Comments on NIST NCSTAR 1 Draft

July 27, 2005

James Quintiere, Prof
Fire Protection Engineering
University of Maryland
College Park, MD 20742
jimq@umd.edu

With suggested changes in red to NIST report by Arthur Scheuerman

Figure 1. UL and Isolatek results.

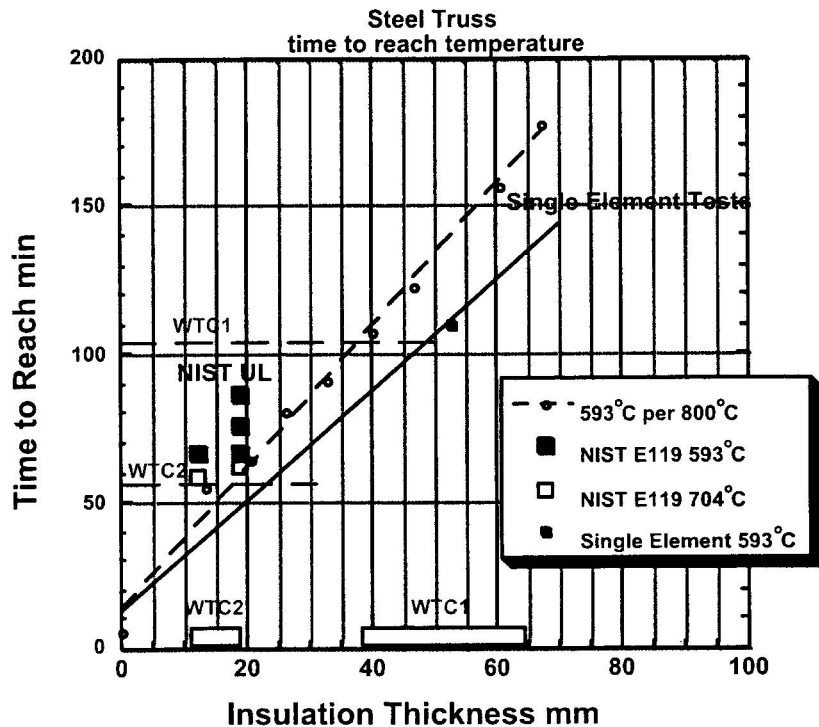
It is noted that the predicted times to reach the critical failure temperature of the truss steel of 55 -73 minutes for WTC 2 and 111 minutes for WTC 1 in Table 1 is consistent with the building collapse times of 56 and 102 minutes, respectively. These predicted heating times are also consistent with the NIST measured heating times (to 66 to 86 minutes, although the reduced scale 17 ft span tests compromised heat transfer) in the UL furnace tests at fire temperatures comparable to 800 °C shown in Table 2 taken from NIST. Indeed, the UL time to reach 1100 °F (593 °C) for the 35 ft span ranges from 66 to 16 minutes which is consistent with 73 minutes in Table 1 and an extrapolated time of 50 minutes for the UL temperature conditions. (See Figure 1.)

Consequently, if the truss elements with specified insulation levels of $\frac{1}{2}$ - $\frac{3}{4}$ in. for WTC 2 and $\frac{1}{2}$ in. for WTC 1 can be heated to about 600 °C in an 800 °C fire at computed times of 55-73 minutes and 111 minutes, respectively, and NIST and others determined that the truss would cause either column buckling or connection failure at 600 °C or below, then this mode of collapse cannot be discounted. This is especially compelling since the collapse times are consistent at 56 and 102 minutes. Moreover, it is commonly known that floor sections were collapsing up to 20 minutes before the full collapse of each of the buildings. NIST has not addressed those early failures.

Figure 2. Predicted upper layer temperatures at various locations on the 97th Floor.

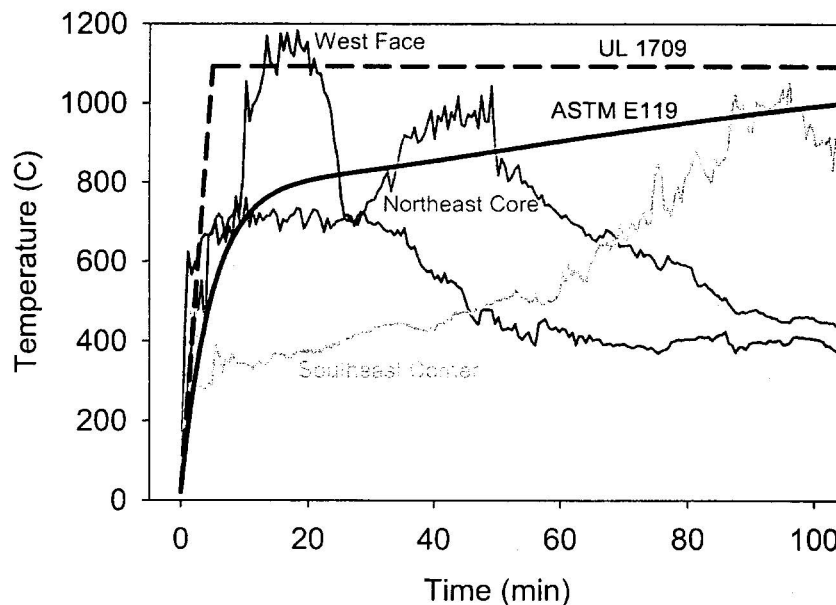
The results of the NIST fire predictions are based on a fuel loading of 4-5 psf. These levels are based on data from the impacted floors of Marsh & McLennan in WTC 1. NIST says this has “high” accuracy [p 119]. They find for WTC 1 that a given floor did not have uniform temperatures. “At any given location, the duration of temperatures near 1,000 °C was about 15 min to 20 min.” [p 127] Upper layer temperatures are shown in Figure 2 for WTC 1 97th floor [NIST]. Temperatures generally exceeded 600°C for about 30 minutes, and for about 60 minutes in the core. In contrast, a scale model test conducted at the University of Maryland, representative of the 96th floor with a simulated fuel load of 11.5 psf, shown in Figure 3 indicates temperatures are generally over 600C(typo?, 600C) for 100 minutes, by(typo?) are much cooler in the core. These results are distinctly different from the NIST simulation. One may be dubious of scale modeling, but it is a tried and true technique.

Figure 3. Temperatures in a scale model of WTC 1 96th floor

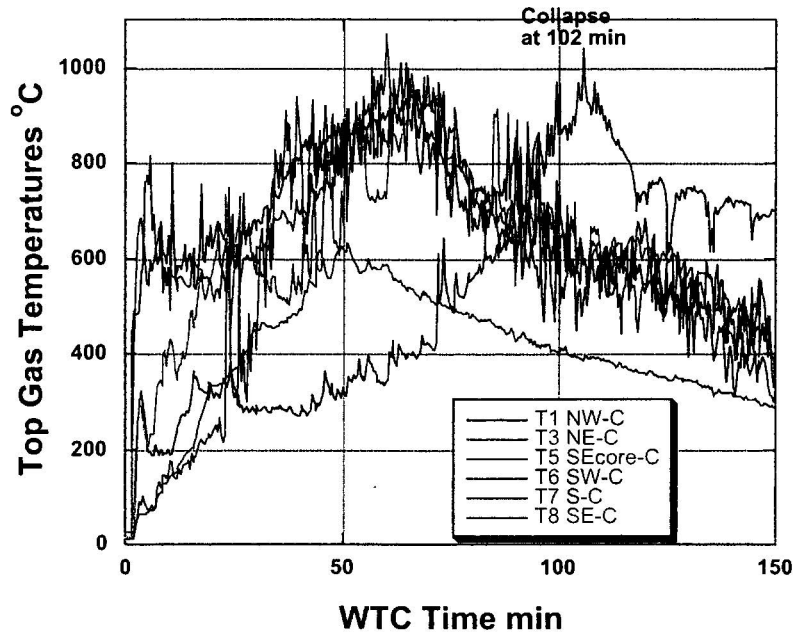
The heavier fuel load in the scale model was based on traditional office loadings and on anecdotal interviews of people familiar with the floors. Subsequently, we conducted a fuel load survey of the 96th floor based on architectural plans obtained from the furniture installer. This led to a conclusion that a loading of 10 psf or greater was the case. Appendix C contains the details in a report. Figure 4 shows a section of the architectural plans used for the 96th floor. A handwritten notation indicates a section of common files that ringed the core of the office space. There were 170 of these 4-drawer lateral files. NIST completely ignored this fuel load (and others) in their assessment. We assigned 100 lbs of paper per draw (a sub-capacity level) giving 68,000 lbs for this contribution. In addition, there were other common files and a storage room that gave a grand total of 95,400 lbs not included by NIST. In the survey conducted by Kate Stewart, estimates of paper and personal items were included in the workstation loads based on typical office conditions. Our total floor combustible loading was estimated at 302,062 lbs compared to 134,640 lbs determined by NIST. Taken over the office floor space area (31,013 ft²), this computes to 9.7 psf and 4.3 psf for NIST. Our paper estimate per file draw is well below

Figure 4. Section of furniture layout WTC 1 96th floor

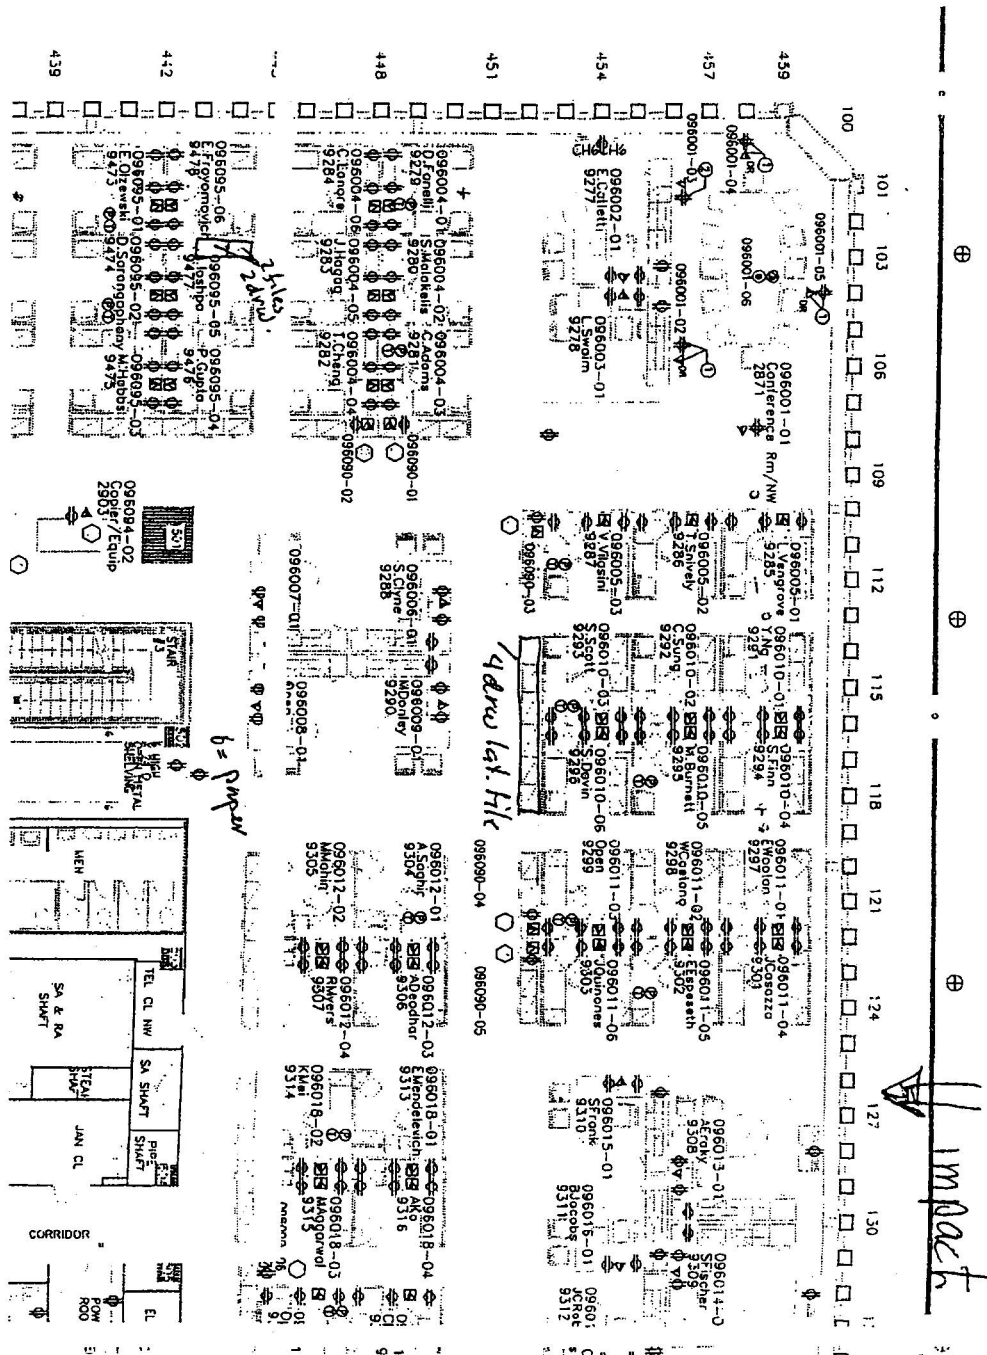
capacity, so the loading we determine is likely too low. Indeed, it was told to us that Marsh was a “paper hog” and “kept everything”. Paper fuel in closed files is de-rated in fire design considerations, but the aircraft impact could have opened the file draws.
